54-4-1 AC Spark Plug Applies to All Engines Equipped With AC LA-87 Spark Plugs, Except Pratt and Whitney R-1830 Engines of 1,200 HP or Less and Wright R-1820 Engines of 1,200 HP or Less.

50-18-3 Air Associates Applies to Model M-264 Safety Belts Incorporating Warren McArthur End Fittings, P/N 275-AS26 (Air Associates P/N M-1842).

FIGURE 1

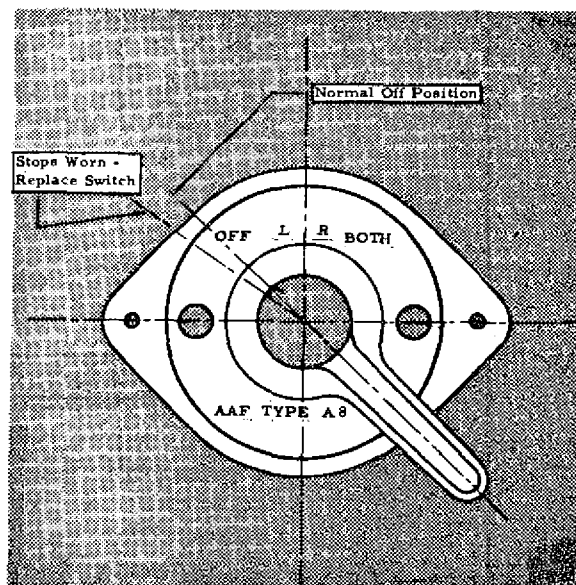
1. Inspection should consist of the following: Check switch lever for overtravel past the "Off" position. Figure 1 shows the location of the switch lever in the "Off" position. The pointer projecting from the lever points to the middle "F" in the word "Off". When the lever can be turned to a point beyond the cen-

terline of the "O" in the word "Off", the rotation stops have become worn and the switch should be replaced.

2. This inspection must be repeated at 100-hour intervals.

FIGURE 1

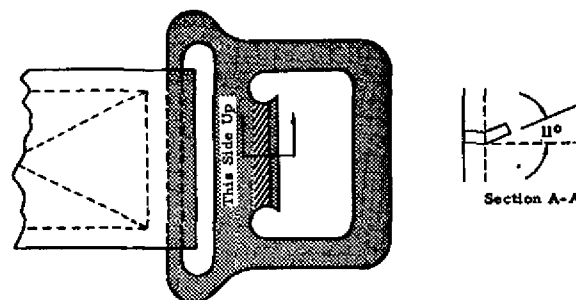
It is possible to improperly fasten the belts effected so that the buckle may become unfastened under load. The unsatisfactory release fittings have a tab bent up to an angle of approximately 11° with the plane of the fitting (see Figure 1).

To provide for securely assembling the buckle with the release fitting in either position, the tab area indicated in the sketch must

be removed or bent flush with the plane of the adjoining metal.
